8 March 2017

Our Ref: 16-147
Your Ref: MCUI2016/1591

RE: RESPONSE TO COUNCILS INFORMATION REQUEST UNDER S278 OF THE SUSTAINABLE PLANNING ACT ASSOCIATED WITH A PROPOSED 'CARAVAN PARK' OVER LOT 45 ON SR835 AT LOT 45 CAPTAIN COOK HIGHWAY, PORT DOUGLAS.

Lidar Map

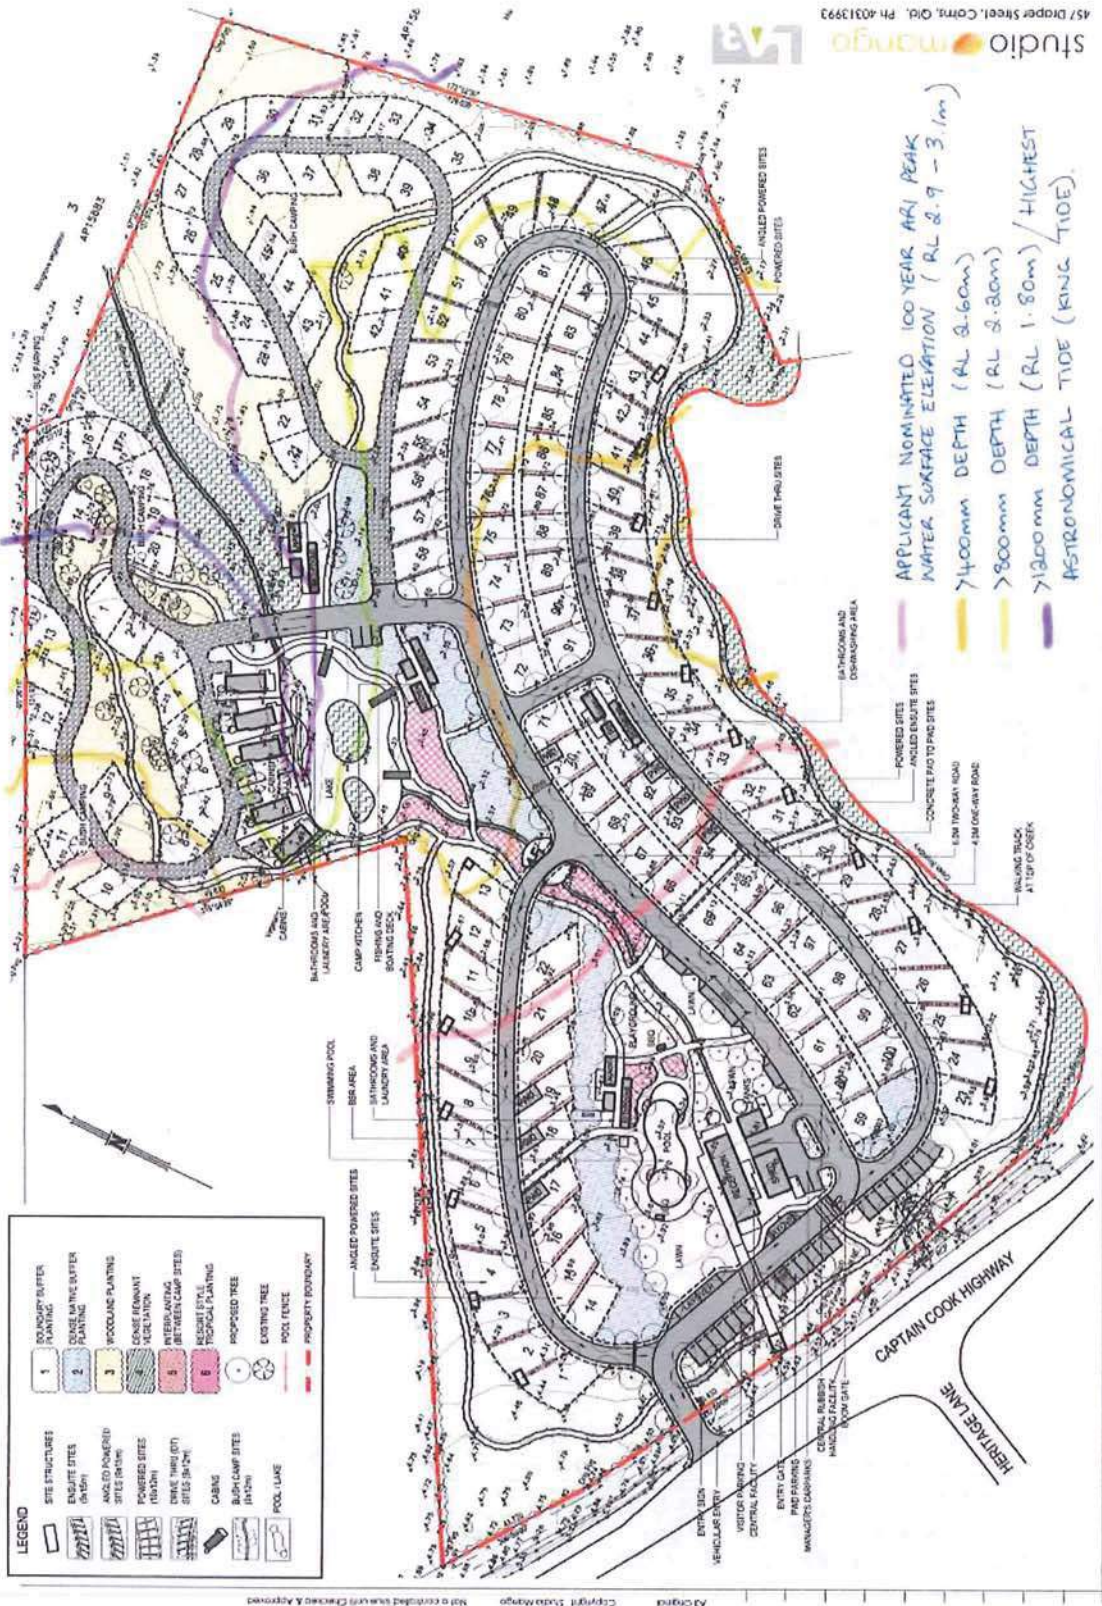
Concern is raised with the depth of inundation in assessing whether the eastern part of the site should be utilised for development. The expected depths of inundation are shown on the attached annotated plan. This gives an indication of the footprint in the various depth ranges (for the 100 year ARI flood event).

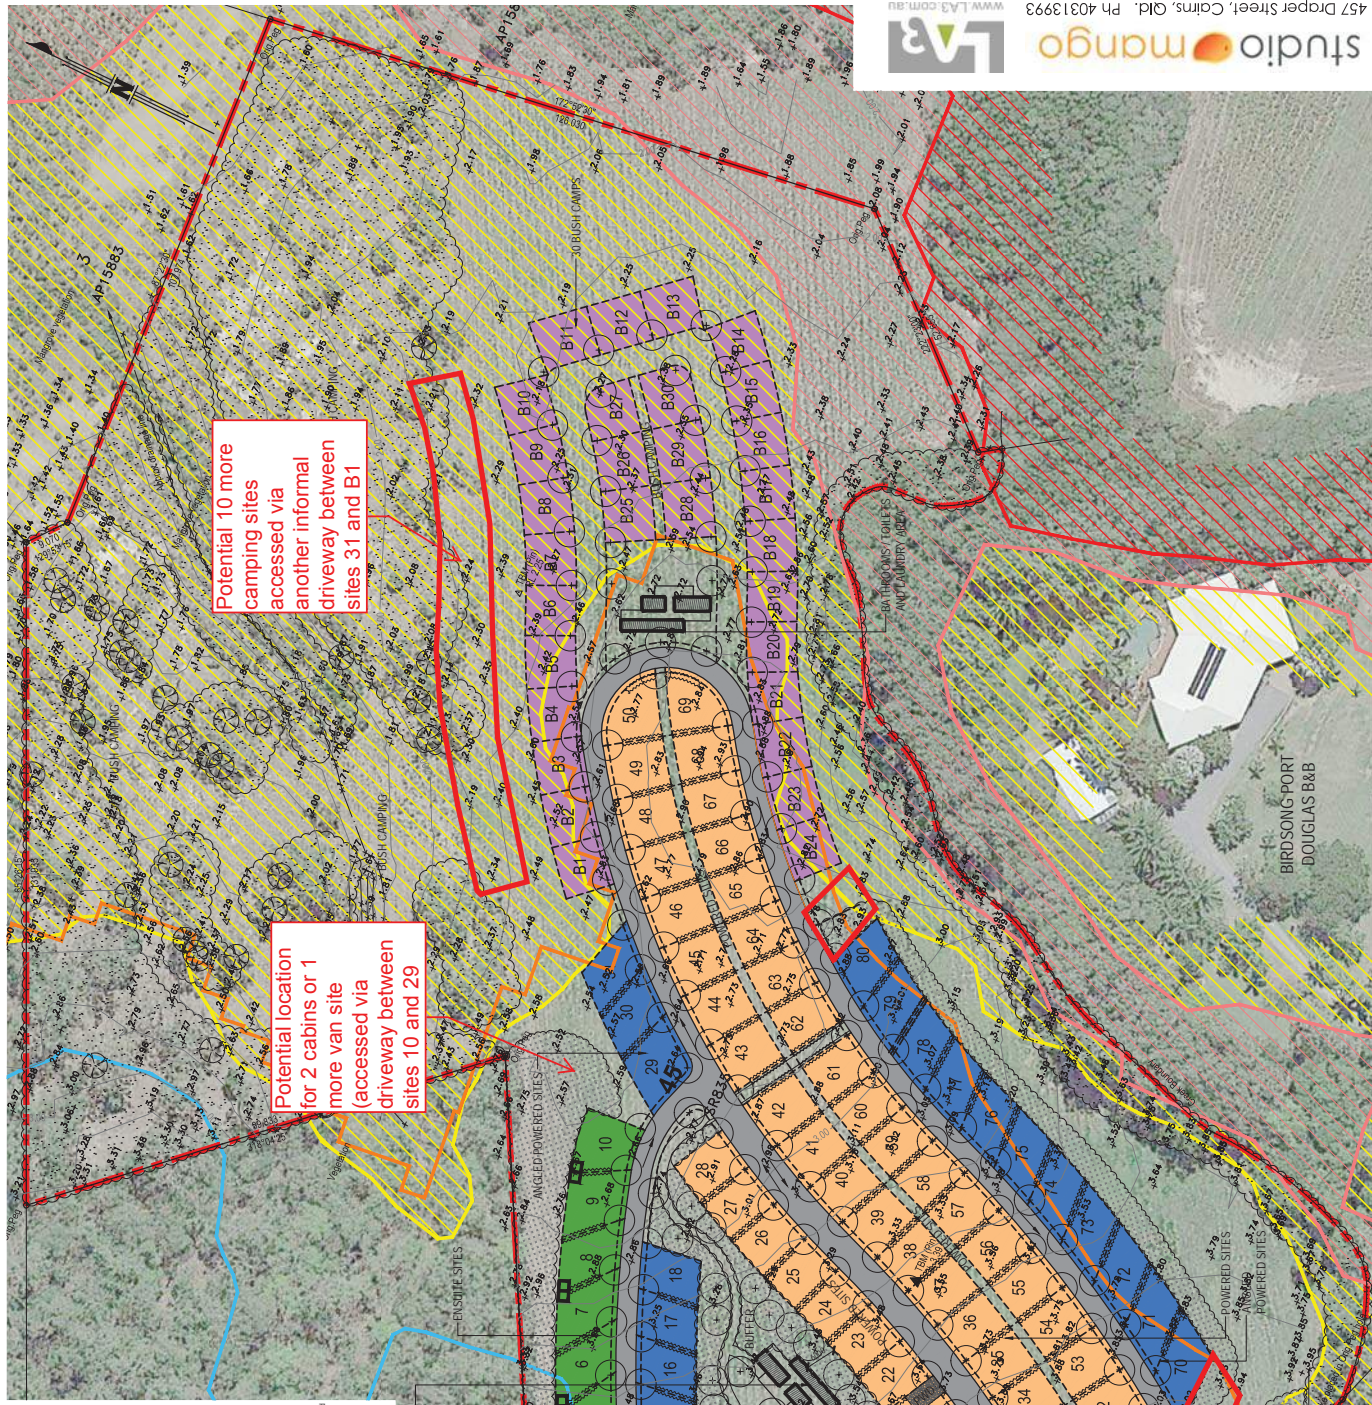
Note that Richard is still playing with feasibility and hence, the reason for my mark ups on the attached plan. We have made so many revisions which is adding the \$\$ up, would prefer your comments first before amending again. As is outlined on the plan, we see there may be an opportunity to include another 5 van sites and some cabins/additional van sites. We are not sure how these will fit amenity wise, but believe we can, with a slight rigging, fit them in within the confines of the risk area, perhaps save the site next to site 81 which has a small area within the higher risk areas, although it is a very minor encroachment and as mentioned, a few extra sites would be handy feaso wise. Happy to discuss. We also think there is an opportunity for another 10 or so bush camping sites, Richard can't see them ever needing more than 40, but I thought better to include them now rather than have to come back and ask for them later.

I note that all the van sites bar sites 9-10 and 29-31 are above the RL 2.7m AHD storm tide inundation level. We do not intend to fill these sites, due to the low number of sites and fact they are less than 200mm under the Q100 storm tide, combined with the lead up time, if a storm tide even is expected, these sites can be evacuated.

Potential 10 more camping sites accessed via another informal driveway between sites 31 and B1

Potential location for 2 cabins or 1 more van site (accessed via driveway between sites 10 and 29)
